CCL Ref: 14806-200422-anderson

20 April 2022

**RC216016: Foodstuffs South Island (Properties) Limited:
Peer Review of Transportation Assessment and Supplementary Information**

Figure 1: Extract from Plan Change 71 Updated Outline Development Plan

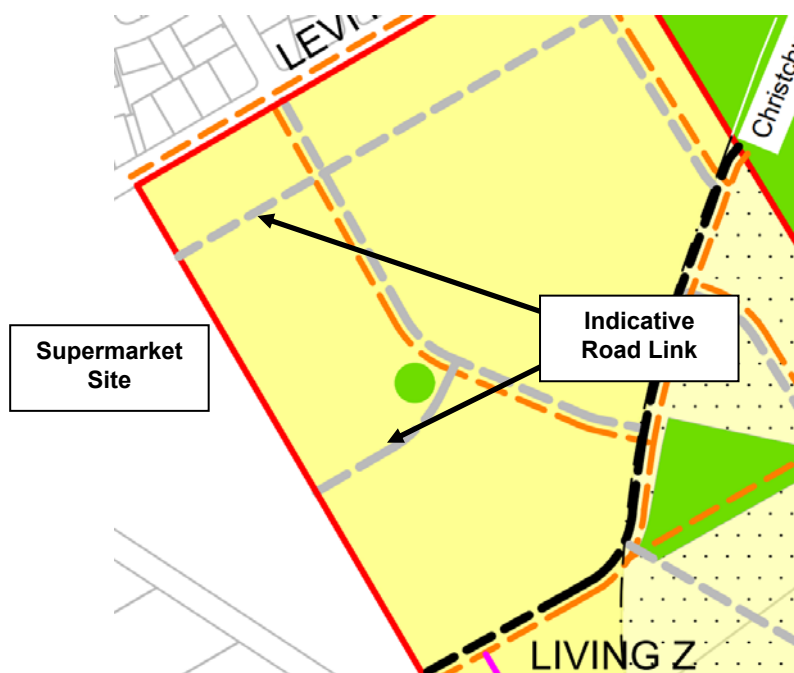
We agree that the extent of car parking provided will be appropriate (as discussed above) and that if Plan Change 71 is approved, then it will mean that a greater number of people are able to access the supermarket on foot or by cycle. However, part of Plan Change 71 shows roading links towards the eastern boundary of the supermarket, and it appears that these could not easily be formed without connecting to the service lane, or by extending the southern east-west route further eastwards (and as noted above, this cannot occur without eliminating the mitigation for larger vehicles crossing the centreline that Abley has relied upon)
